MIL-B-43401
AMENDMENT-2

MILITARY SPECIFICATION

BOWL, BAPTISMAL

This amendment forms a part of Military Specification MIL-B-43401, dated 13 January 1966, and is mandatory for use by all Departments and Agencies of the Department of Defense.

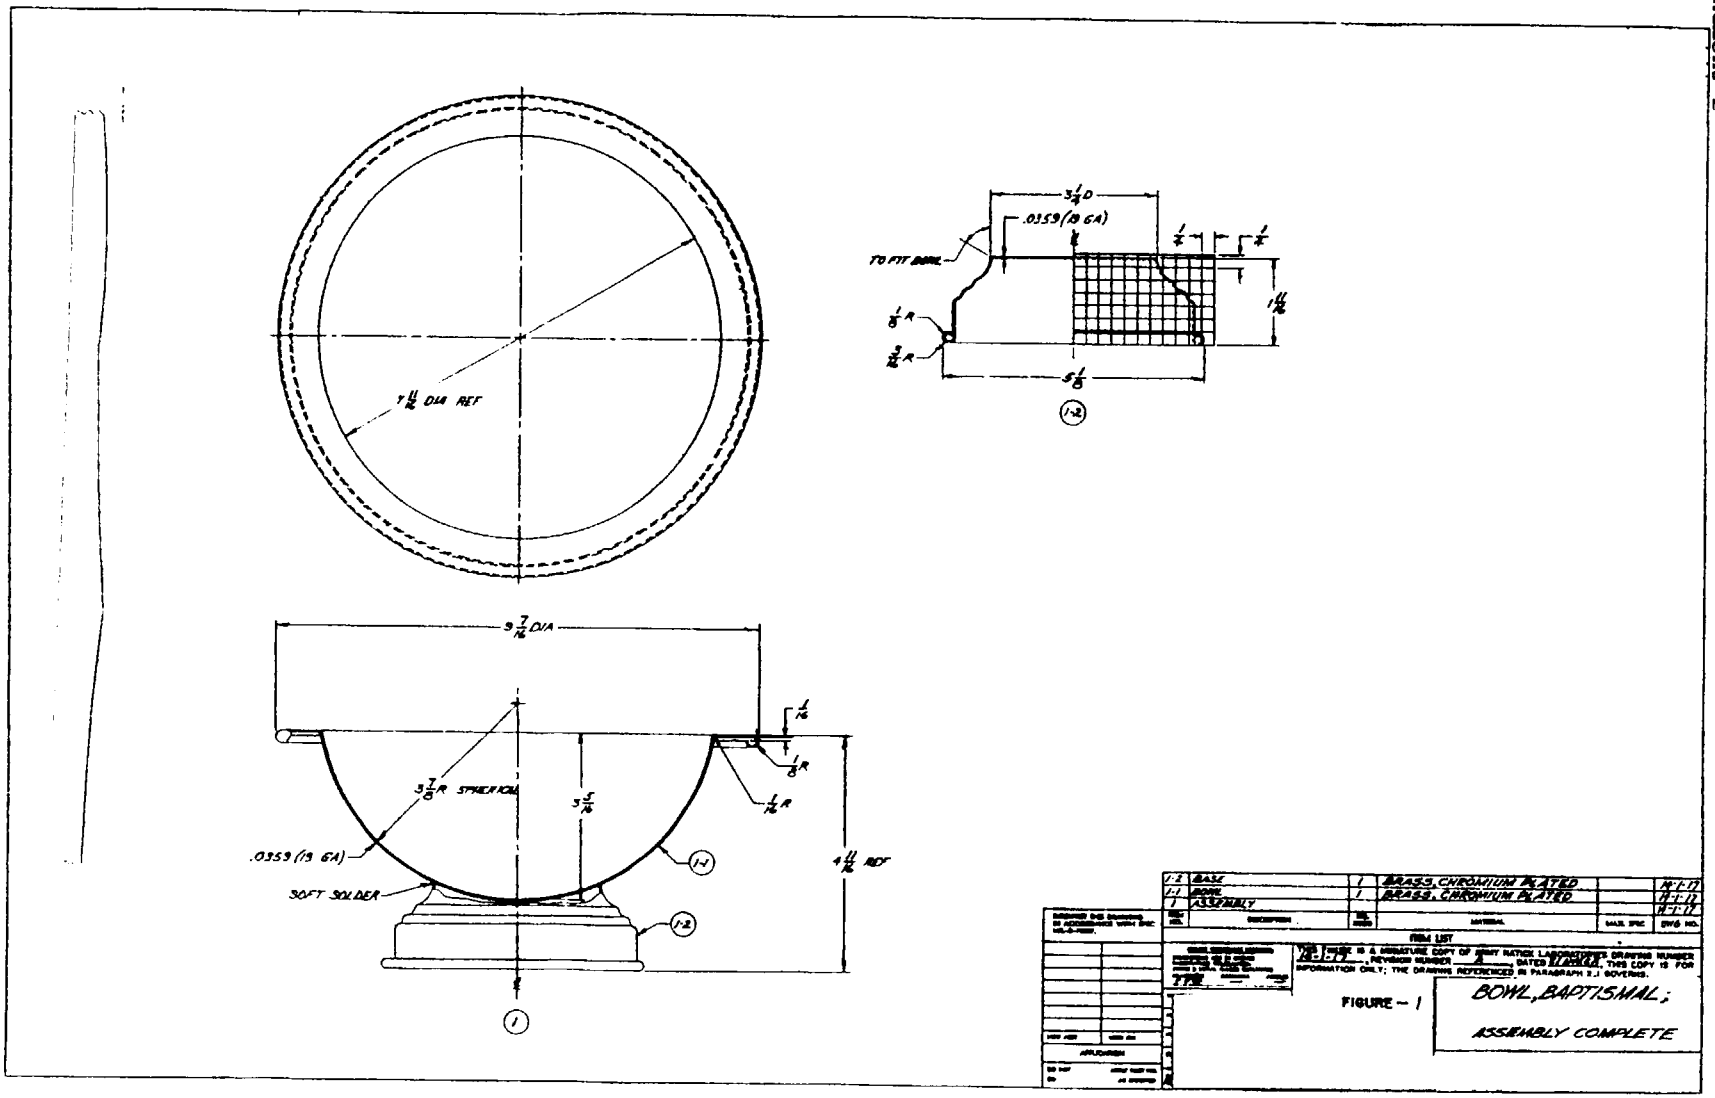
Figure 1.- Delete and substitute new figure 1 attached.
